## Saybrook Stormwater Management Basin Inspection Summary

SEA #: 6431-SAYB

June 28, 2018

**Photo 28**

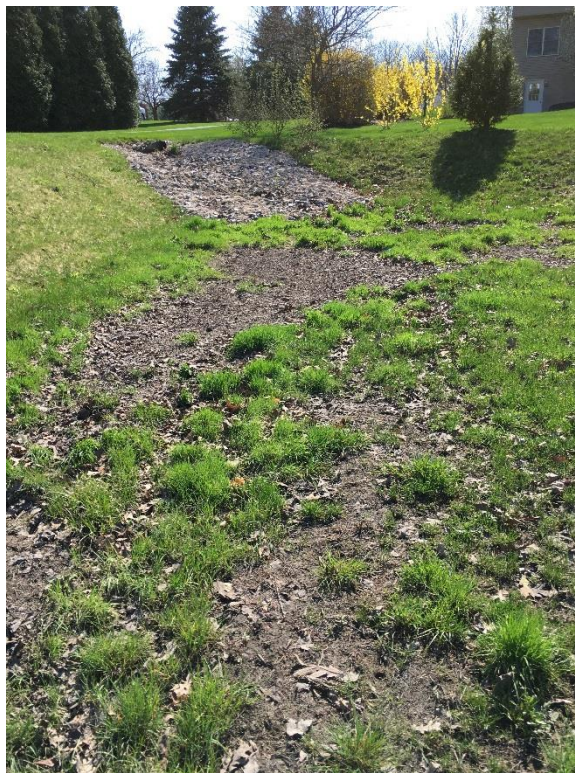
The lower portion of the basin bottom is caked with sediment and is not likely to grow vegetation without soil amendment and plantings.

Vegetation in the upper portion of the basin is patchy with bare areas.

- Clean around outlet structures. Remove leaves and other dead vegetation
- Modification should be made to restore infiltration:
  - Remove approximately 8" of clayey soil,

- Till basin bottom,
  - Place 6" of topsoil per Saybrook Final Subdivision Plan Phase 10, Post Construction Stormwater Management Plan, Sheet PSCM 2, dated 3/21/14.

- Vegetate to achieve a uniform 70% perennial vegetative cover per PA Code Ch 102.22(a)(2)(ii).
- Place riprap at the outlet of the northeast inflow pipe as noted on Saybrook Final Subdivision Plan Phase 10, Post Construction Stormwater Management Plan, Sheet No PSCM 1, dated 3/31/14.

Figure 4. Test pit/infiltration test locations Basin 4.

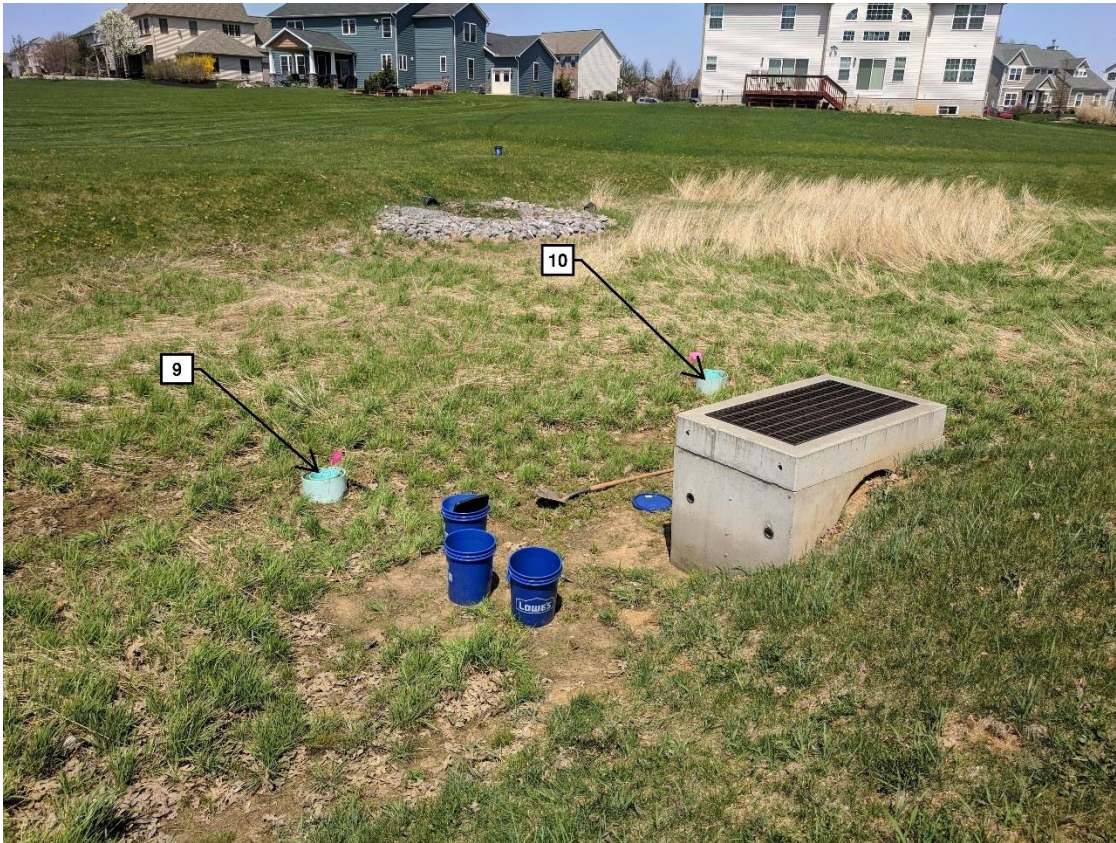
Infiltration testing in Basin 4 was conducted on 5/3/18. According to the design plans, the basin has been designed for infiltration across the bottom. Figure 4 shows the locations of the test pits. Photos 33-36 document the basin condition and testing observations. The average infiltration rate for Basin 4 was 9.32 in/hr.

- Clean around outlet structures. Remove leaves and other dead vegetation.
- Establish permanent vegetation in areas of bare soil to meet a uniform 70% vegetative cover per PA Code Ch 102.22(a)(2)(ii).
